DESIGN	PH	DART AEROSPACE LTD	
DRAWN	RF	HAWKESBURY, ONTARIO, CANADA	
CHECKED	9	DRAWING NO.	REV. E
MFG. APPR.	DS	D412-664-243	SHEET 2 OF 4
APPROVED	140	TITLE	SCALE
DE APPR.	14	CROSSTUBE ASSEMBLY (412 HI AFT)	NTS
DATE	09.09.30	COPYRIGHT © 2001 BY DART AEROSPACE LTD <small>THIS DOCUMENT IS PRIVATE AND CONFIDENTIAL AND IS SUPPLIED ON THE EXPRESS CONDITION THAT IT IS NOT TO BE USED FOR ANY PURPOSE OR COPIED OR COMMUNICATED TO ANY OTHER PERSON WITHOUT WRITTEN PERMISSION FROM DART AEROSPACE LTD.</small>

DRAWING NO. D412-664-243	TITLE CROSSTUBE ASS'Y (412 HI AFT)	REV. E	DART AEROSPACE LTD ENGINEERING ORDER		D.E.O. NO. D412-664-243-E-2	SHEET NO. SHEET 1 OF 1	SCALE NTS
DRAWN <i>q</i>	CHECKED <i>AS</i>	MFG. APPR. <i>R</i>	APPROVED <i>MP</i>		DE APPR. <i>#</i>		
DATE 11.09.07	DATE 11.09.19	DATE 11.09.19	DATE 11.09.19		DATE 11.09.19

DRAWING NO. D412-664-243	TITLE CROSSTUBE ASSEMBLY (412 HI AFT)	REV. E	DART AEROSPACE LTD ENGINEERING ORDER		D.E.O. NO. D412-664-243-E-4	SHEET NO. SHEET 1 OF 3	SCALE NTS
DRAWN <i>MP</i>	CHECKED <i>A</i>	MFG. APPR. <i>A</i>	APPROVED <i>MP</i>	DE APPR. <i>MP</i>			
DATE 12.08.21	DATE 12.08.30	DATE 12.08.30	DATE 12/8/30	DATE 12.08.30

**D412-664-243
ASSEMBLY DETAIL**

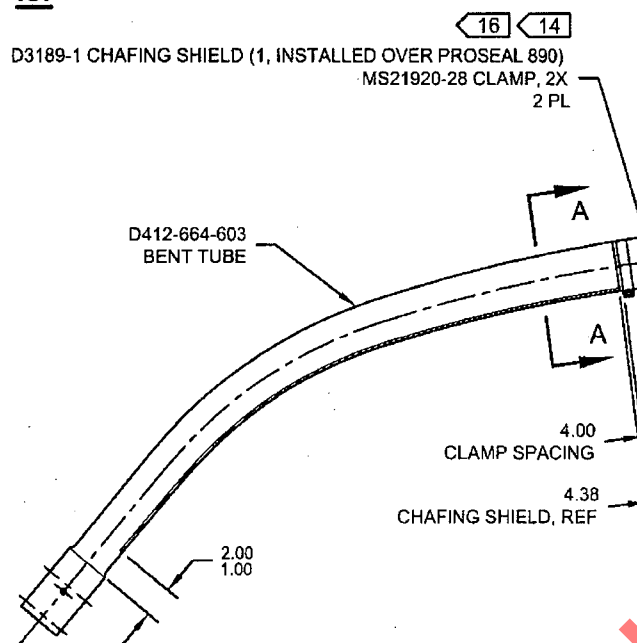
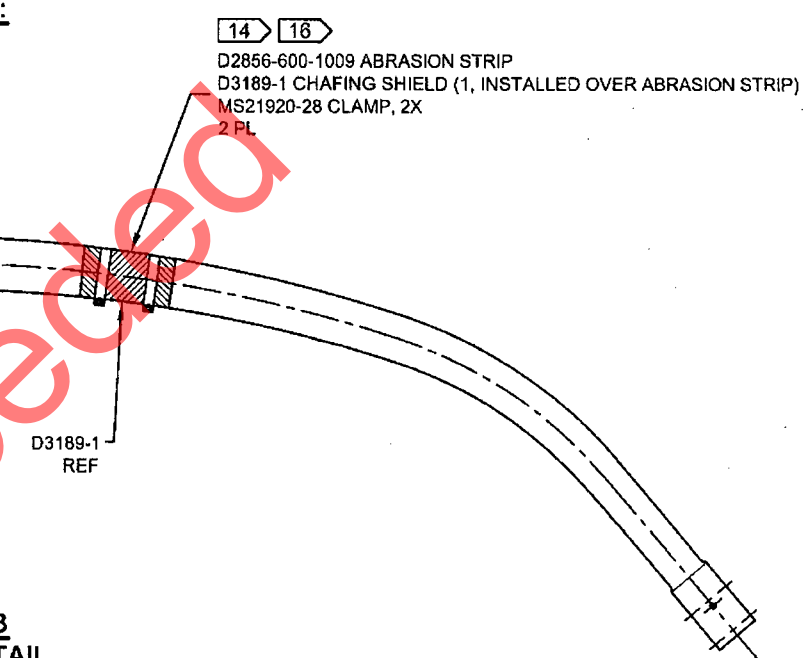
REMOVED ABRASION STRIP IN FAVOR OF A THIN LAYER OF PROSEAL 890. UPDATE INSTALLATION OF CHAFING SHIELDS AND REDUCE TORQUE TO 40-50 IN-LBS. THIS ENGINEERING ORDER SUPERCEDES DEO D412-664-243-E-1.

- 2) FINISH: CHEMICAL CONVERSION COAT PER DART QSI 005 4.1
PRIME INSIDE AND OUTSIDE PER DART QSI 005 4.2
MASK UNDERSIDE OF CROSSTUBE AS SHOWN (HATCHED AREA)
PAINT OUTSIDE PER DART QSI 005 4.2
AFTER PAINTING, APPLY CLEAR COAT ON HATCHED AREA
- 14) APPLY A THIN COAT OF PROSEAL 890 ON INSIDE CONCAVE SURFACE OF D3189-1 CHAFING SHIELD AND LET CURE PER MANUFACTURER'S INSTRUCTIONS. INSTALL PROSEALED D3189-1 CHAFING SHIELD ONTO CROSSTUBE BY APPLYING A THIN COAT OF PROSEAL 890 ONTO CROSSTUBE. BE SURE TO ELIMINATE ANY AIR GAPS.
- 16) TORQUE CLAMPS ON D2896-1 SUPPORT 80 TO 100 IN-LB. **TORQUE CLAMPS ON D3189-1 CHAFING SHIELD 40 TO 50 IN-LB.**
ENSURE AT LEAST 1.5 THREADS SHOWING IN SAFETY AND THAT NUT HAS NOT BOTTOMED-OUT AFTER TORQUING.
